District of Columbia Fire & EMS Department
 Fire Prevention Division
 1100 4th Street SW Suite E700
 Washington, D.C. 20024

RE: Fire Department Access Road Dispute between the United States Department of State and United States Institute of Peace

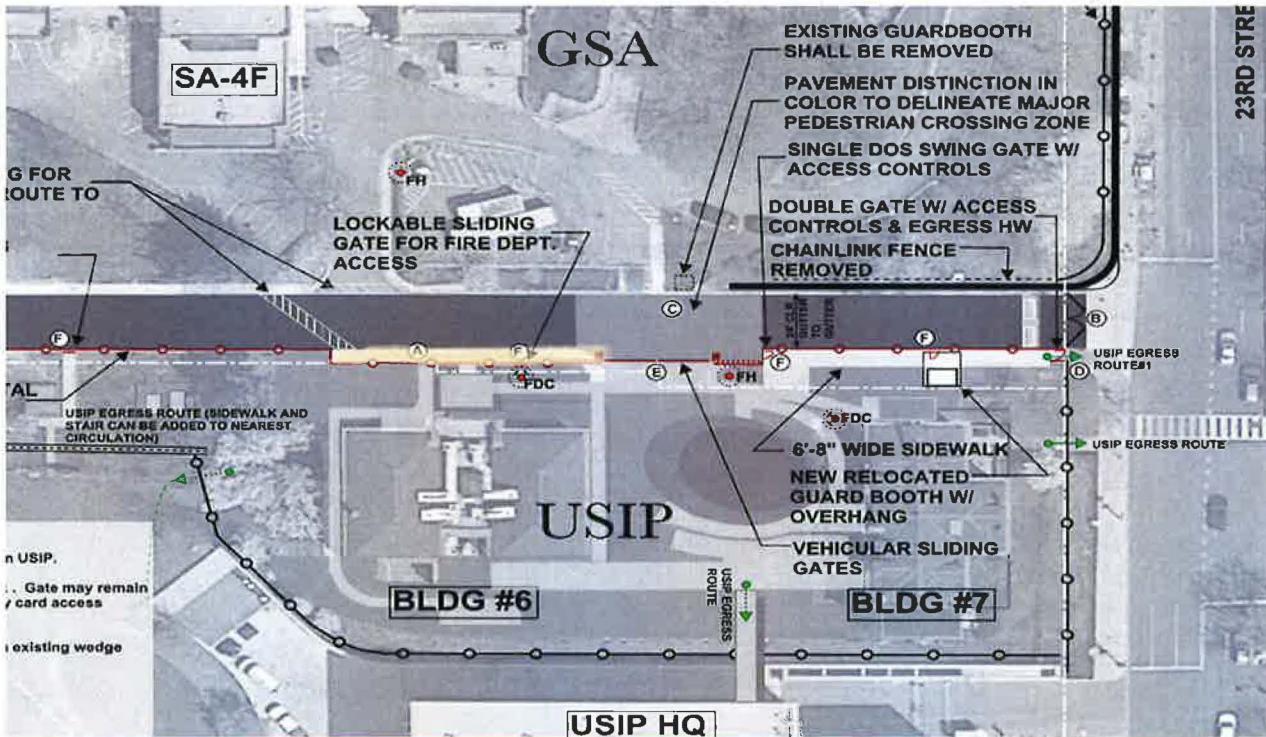
The gate installed should be the type that has sliding access openings as those presented in the drawing below. This will prevent blocking any portion of the current fire department access in place upon its opening. Additionally, the gate should be designed so that the sliding access opening has the required dimensions to accommodate fire apparatus access to the grounds of the United States Institute of Peace.

Further, the gate should be constructed as to provide clear and unobstructed access to the fire hydrant and the fire department connection on the property of the United States Institute of Peace. Also, the sidewalk area in front of the FDC for Building No. 6 should be fenced in a way that makes it accessible on the United States Institute of Peace side.
